GFA AIRWORTHINESS DIRECTIVE

TYPE AFFECTED: SZD-50-3 PUCHACZ. ALL SERIAL NO'S.

SUBJECT: Failure of Pushrod End Bearing in elevator circuit.

SZD-50-3 PUCHACZ AD-623

Broken rod end bearing showing extent of bending prior to failure. Note profile of locktab to suit keyway.

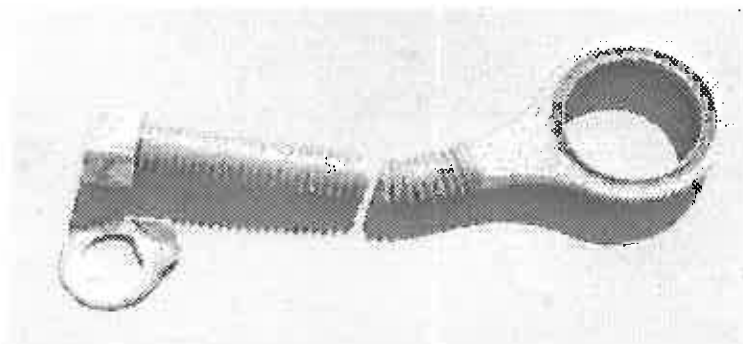
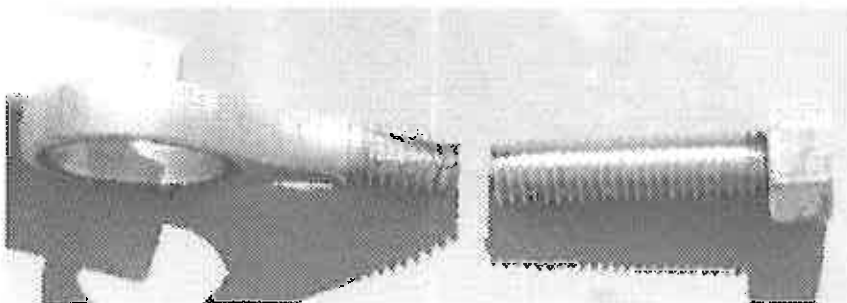
FINDINGS: On inspection it was found that the rear rod end bearing of the elevator pushrod which connects the front and rear control columns had broken at the point where the threaded portion enters the locknut. The pushrod was therefore completely detached from the rear stick.

Continuing investigations indicate that the end bearing which failed was mechanically damaged well prior to the failure, and although not yet positively established, it is believed that the end bearing was bent by a person treading on the push rod or end bearing while entering or exiting the rear cockpit; not by loads imposed during flight.

Broken rod end bearing showing keyway.

1. The pushrod connecting the front & rear control columns is to be examined critically. This is the pushrod which runs down the left side of the cockpit. Remove the rear rod end from the pushrod and inspect the threaded area for bending or cracks using a 10X magnifier.
2. Notify GFA Airworthiness Department without delay of the results of this inspection *whether cracks are found or not*.

3. Visually inspect all other rod ends in the control circuits for any sign of bending in the threaded area. The positions of any rod ends with a keyway are to be noted and their locations advised to GFA.

4. Any suspect rod ends must be replaced with serviceable components before further flight.

The rear end of the elevator pushrod which connects the front and rear control columns is to be visually inspected for any sign of bending in the rod or the end bearing. If damage is suspected carry out item 4 of “Action A”.
